ADDENDUM - 01

PARTIAL HVAC RENOVATION-MARY
SHOEMAKER SCHOOL

RYEB Project #5652Aa

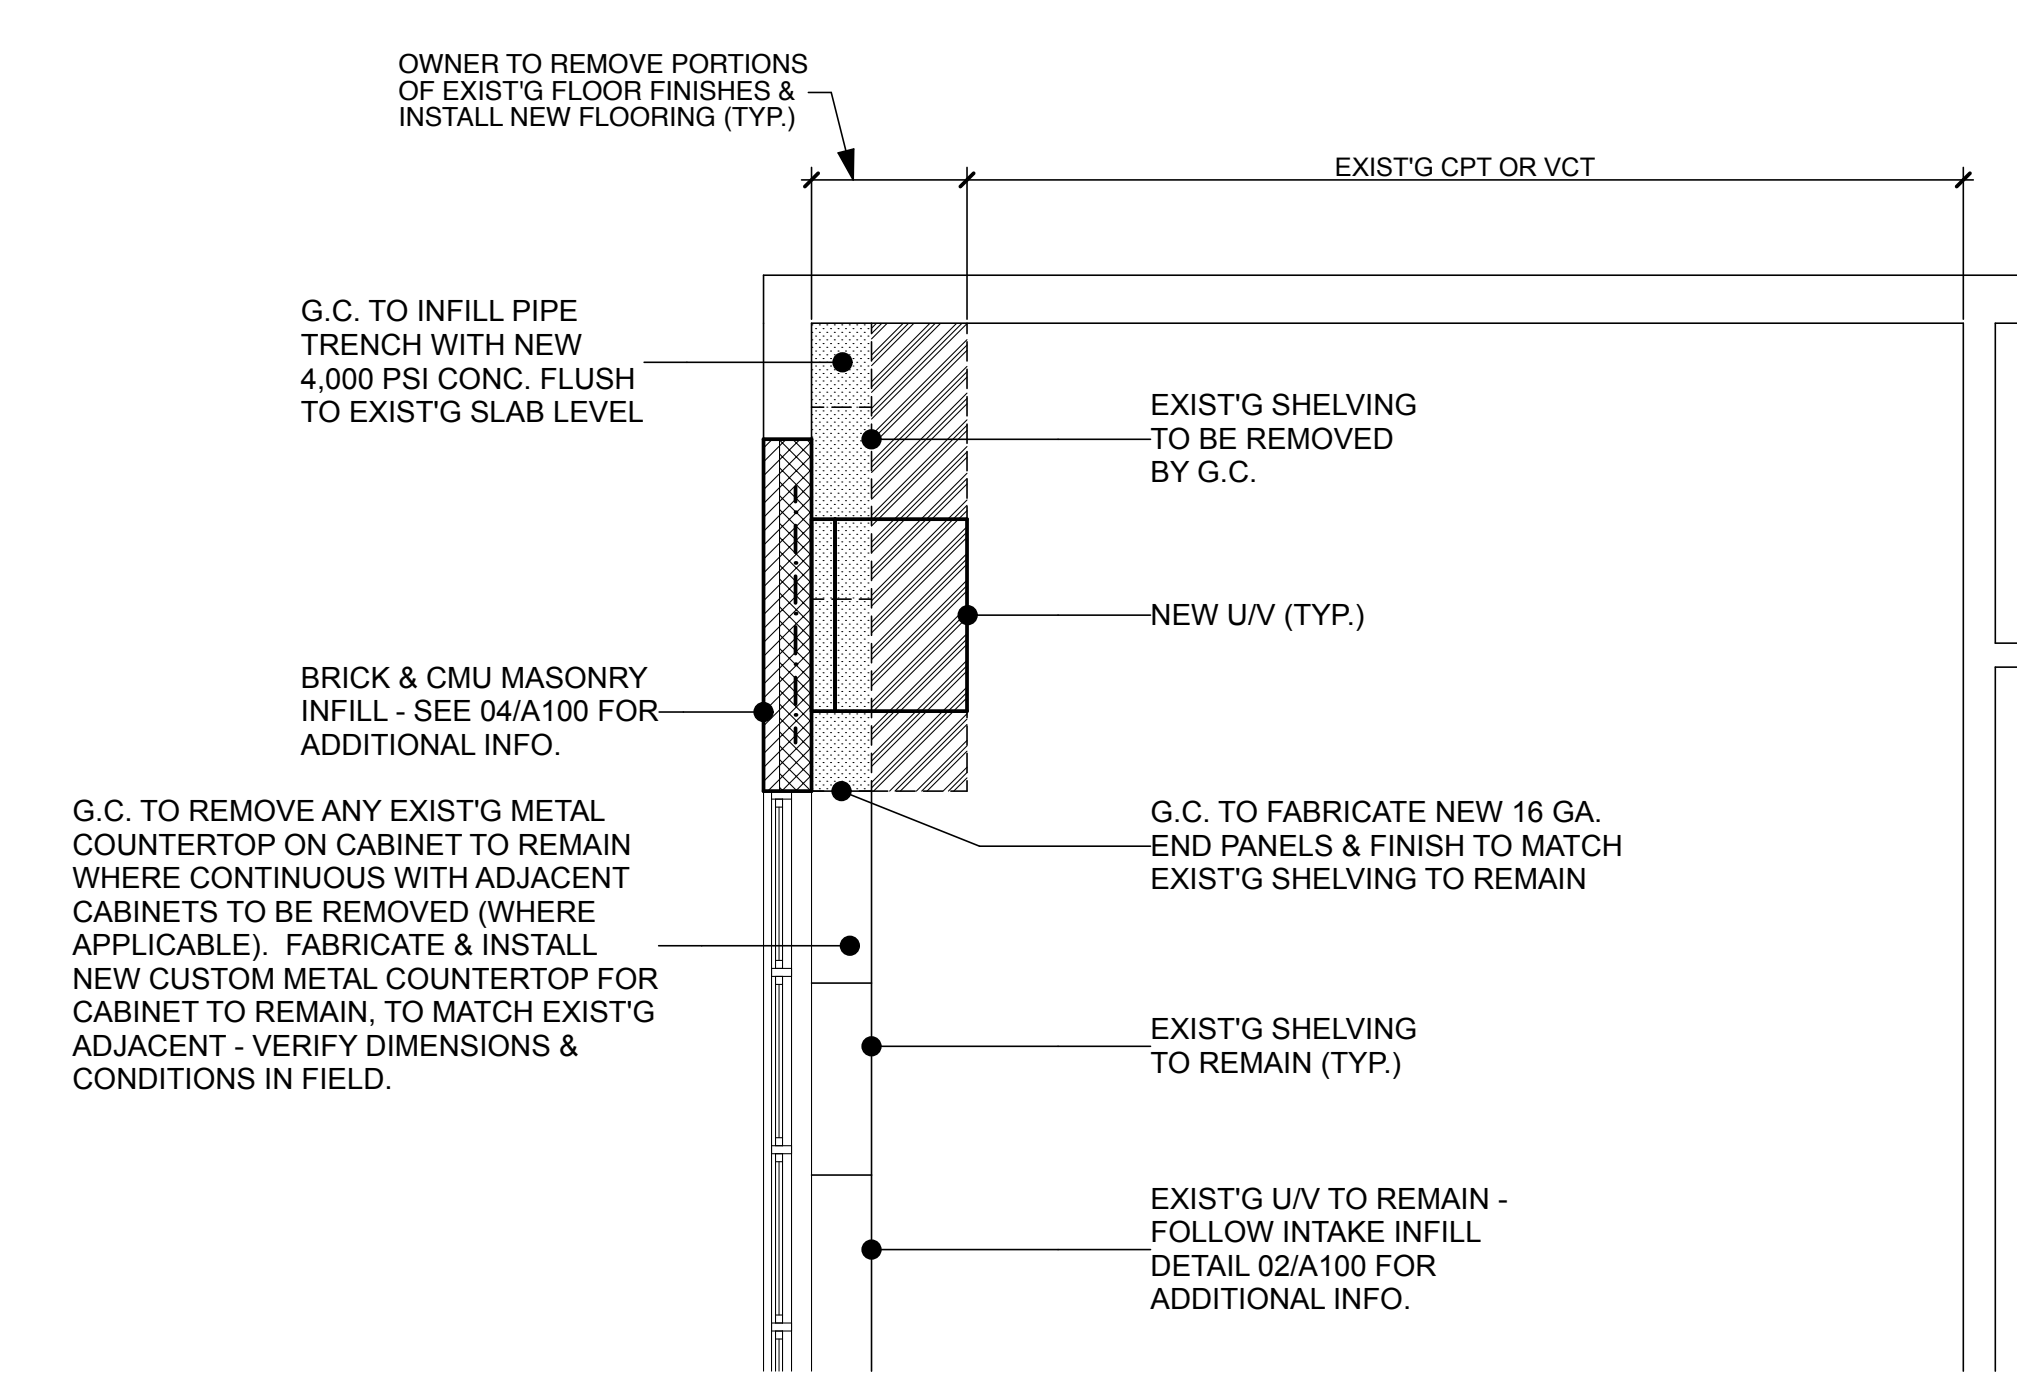
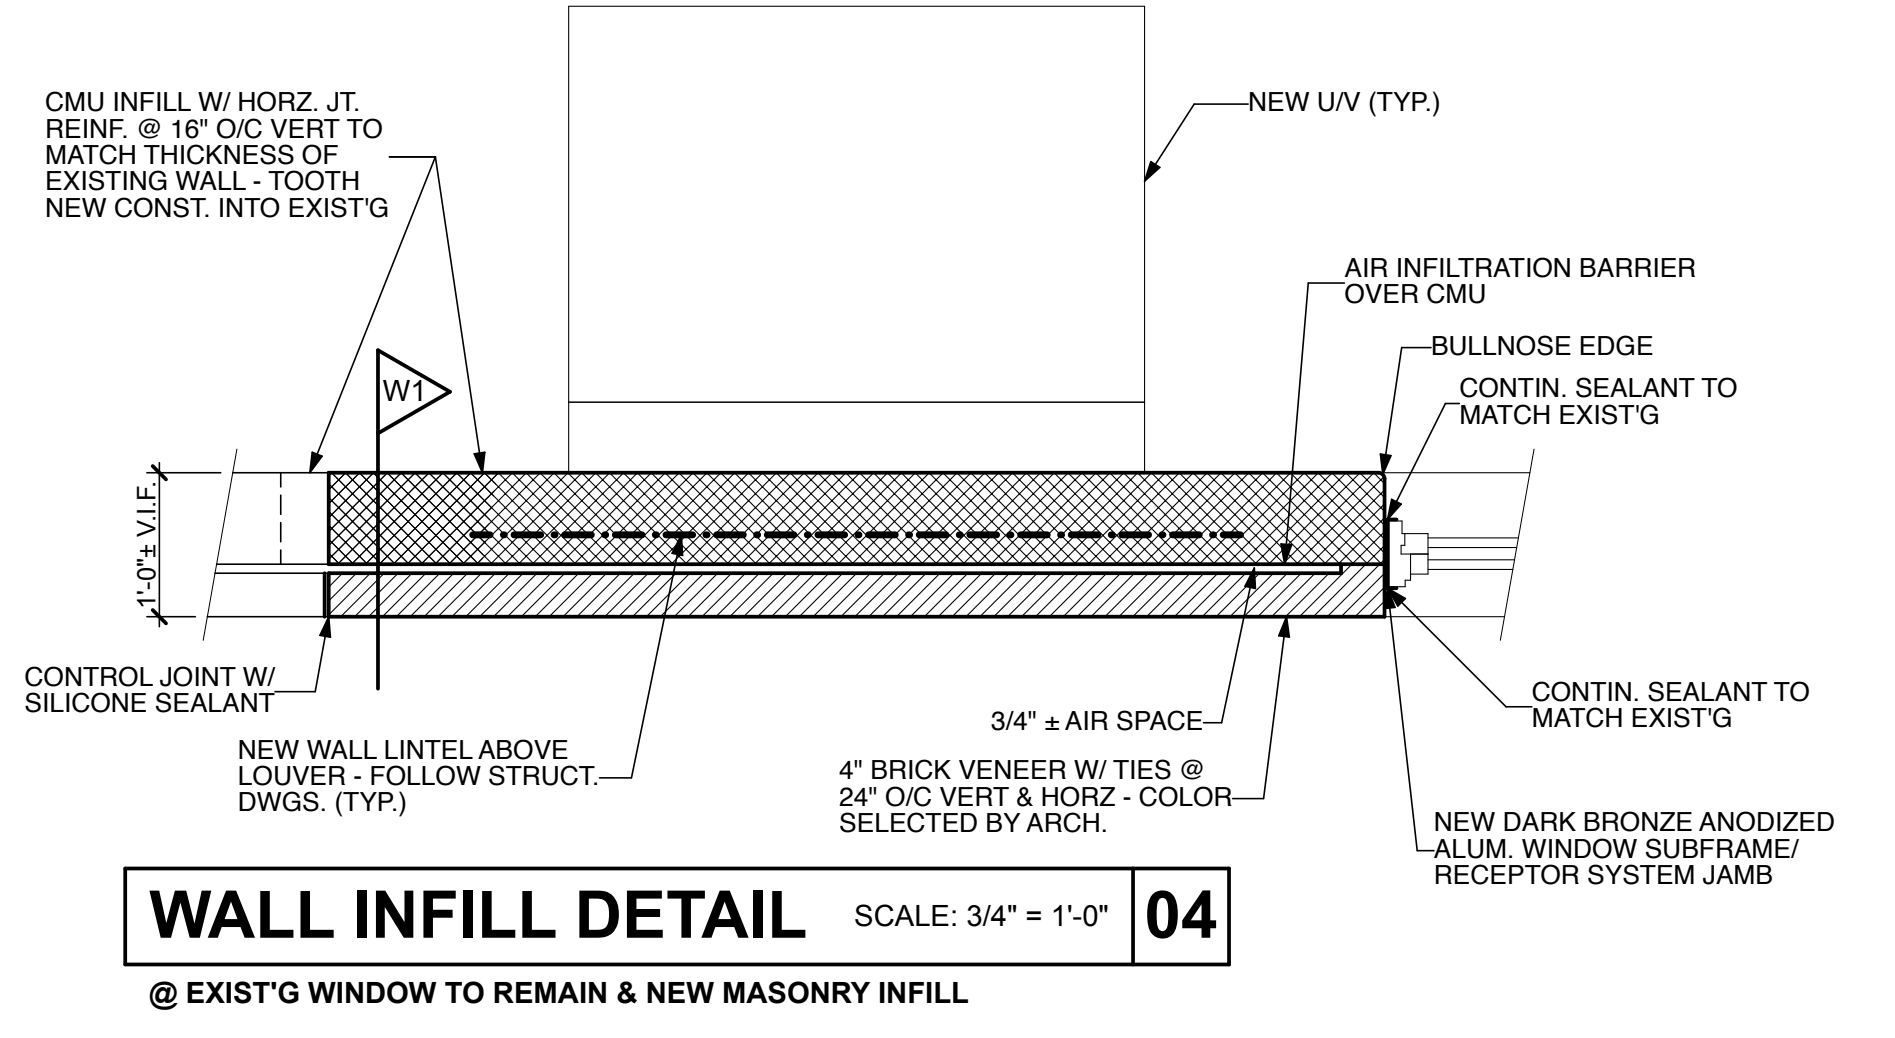
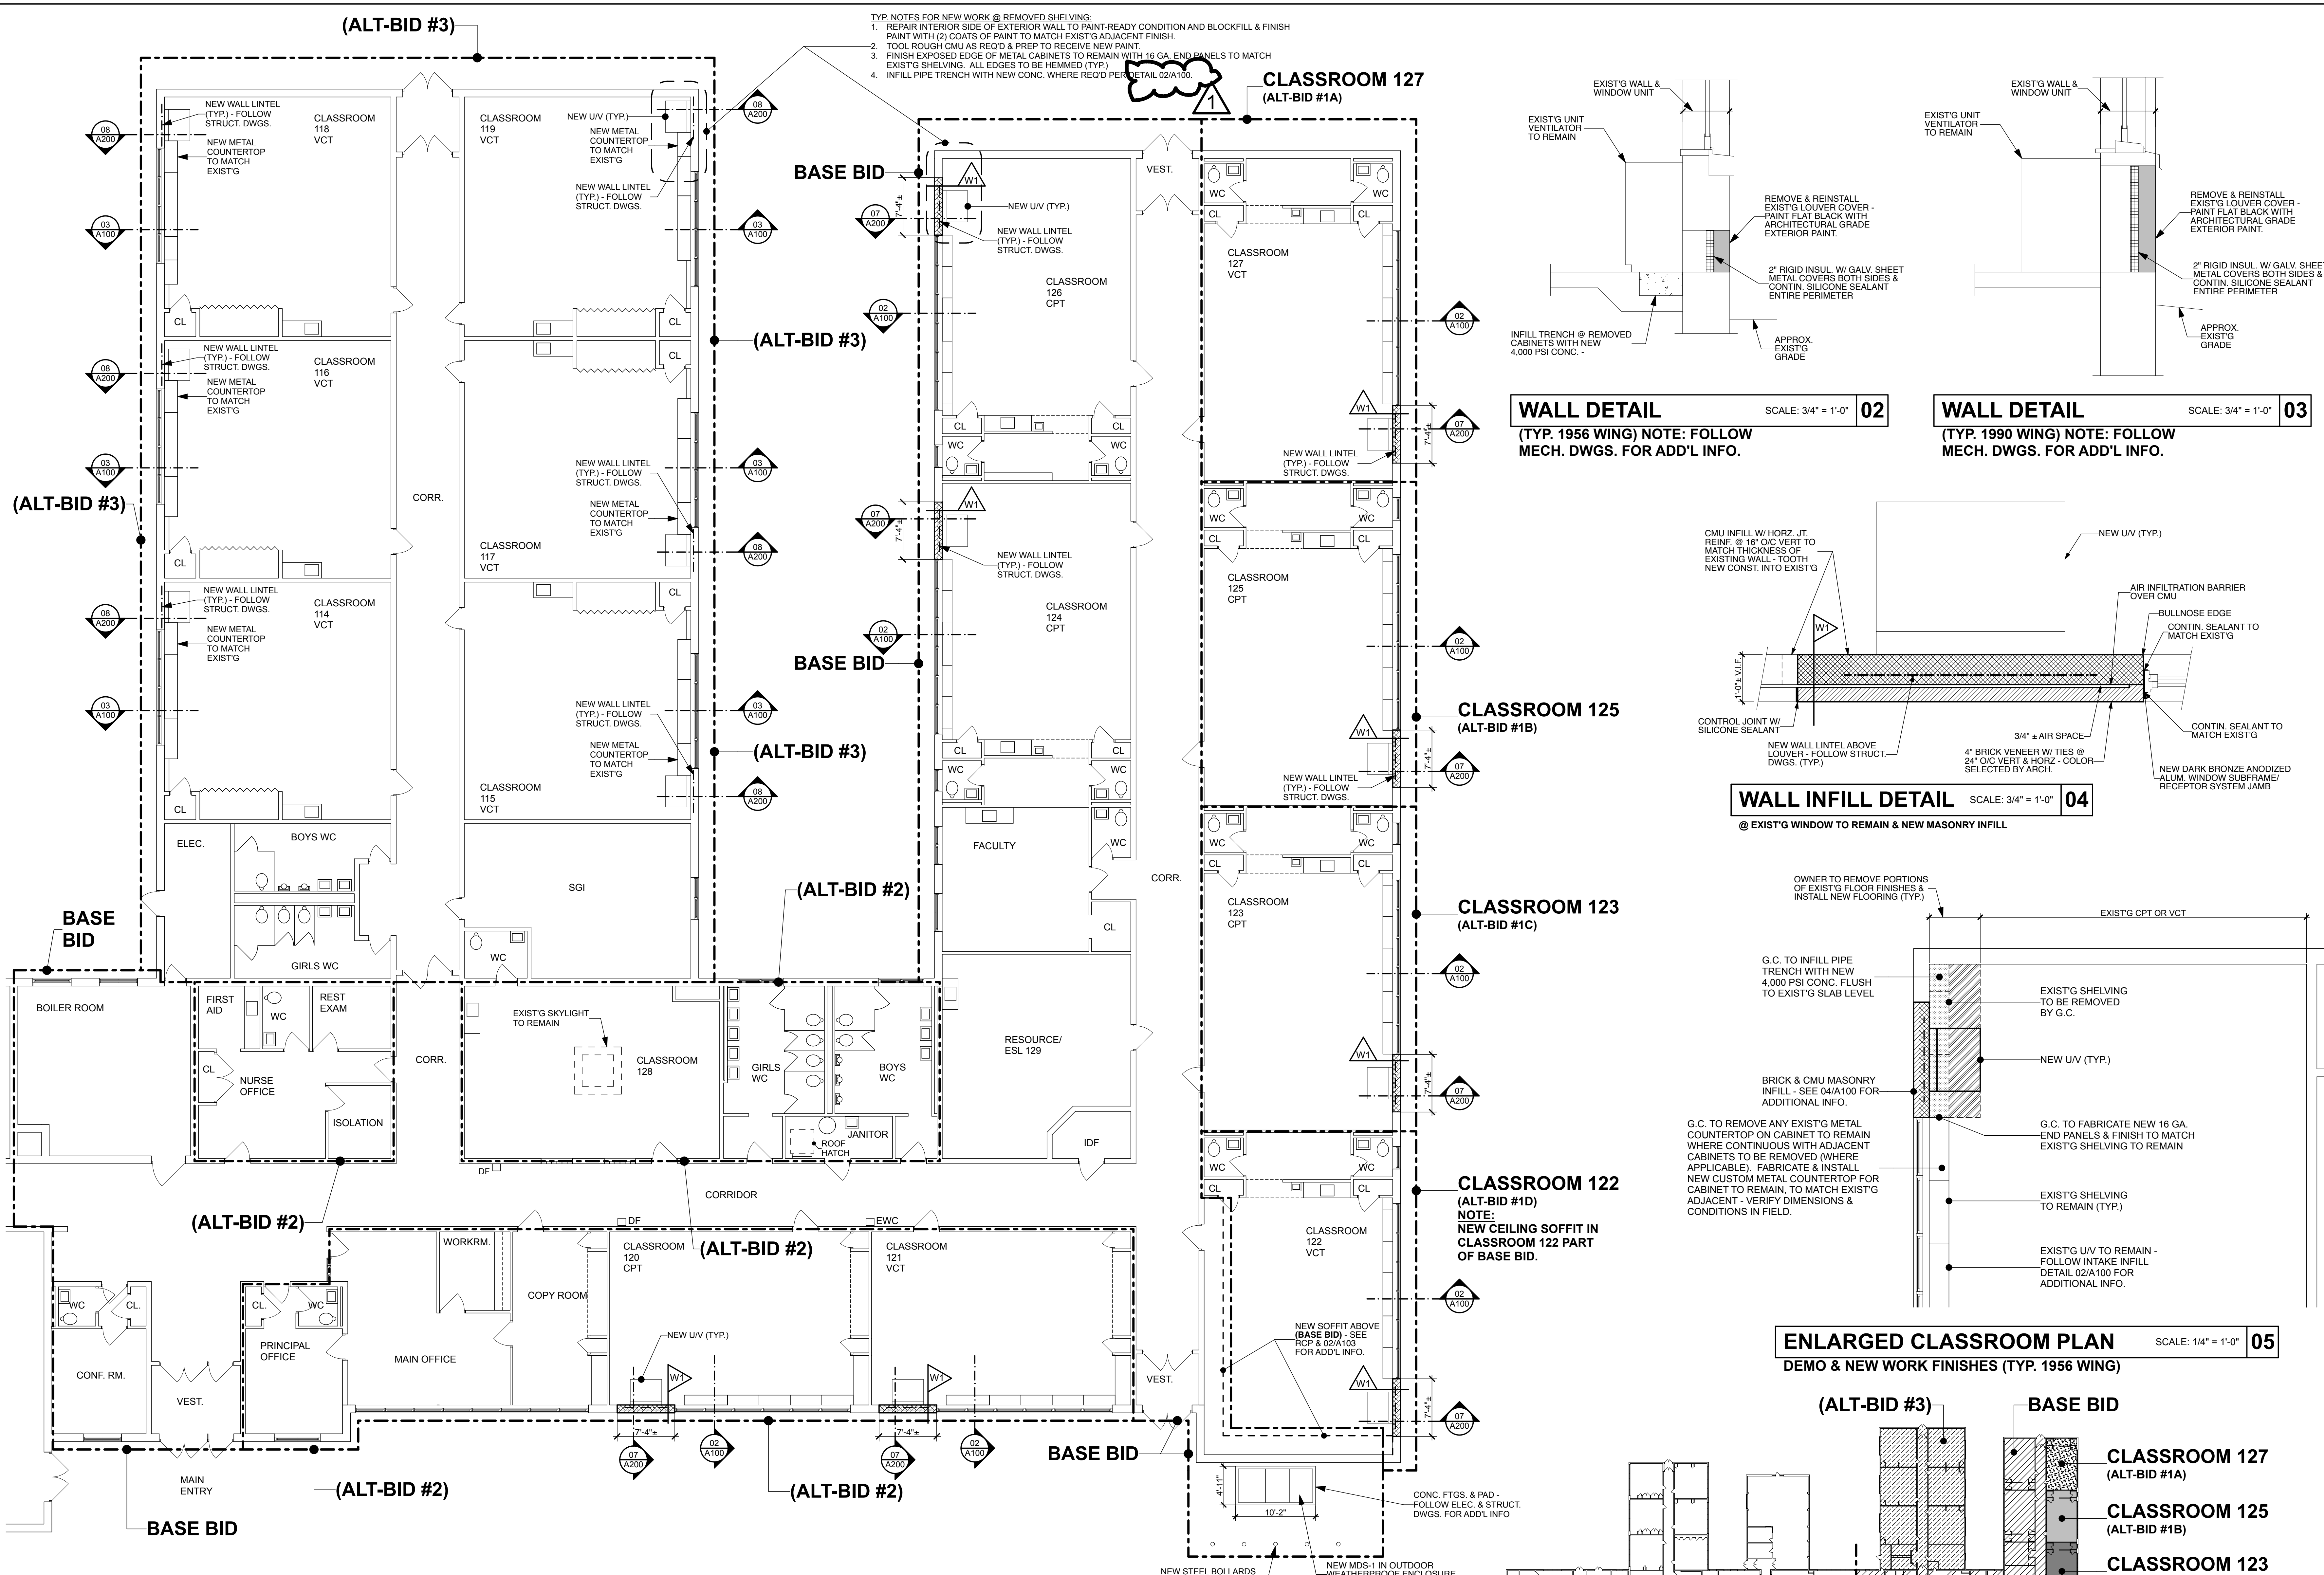
- 1.12 **Clarification:** All new steel angles in exterior walls shall be galvanized steel.
- 1.13 **Bidder Question:** Drawing A000, Note #17-this note is to remove and reinstall the window shades. Just want to confirm this is only as needed to perform our work. **Response:** Correct. The intent is to only remove what is required to be removed (if any) for the Contractor to conduct their work. Please review Topic 1.07 for related information where the new masonry walls will be constructed.

- 1.14 **Bidder Question:** Can you please quantify how many 16 x 16 plenum openings above the ceiling need to be patched? **Response:** Refer to amended drawing A000 included as part of this Addendum that shows the approximate locations of the CMU infill of existing plenum openings. The infill of the plenum openings shall be part of the assigned Base-Bid, or each applicable Alternate.

- 1.15 **Bidder Question:** Drawing A000, Note #15 in Room 122. Is this note correct? **Response:** Note #15 is correct in Room 122, and all other rooms where the note is referenced. There is an existing stone windowsill that will need to be removed where the windows are to be demolished and where the new masonry infill wall will be constructed. Furthermore, the Contractor is required

to carefully remove the existing stone windowsill in a manner to prevent damage to the adjacent construction to remain.
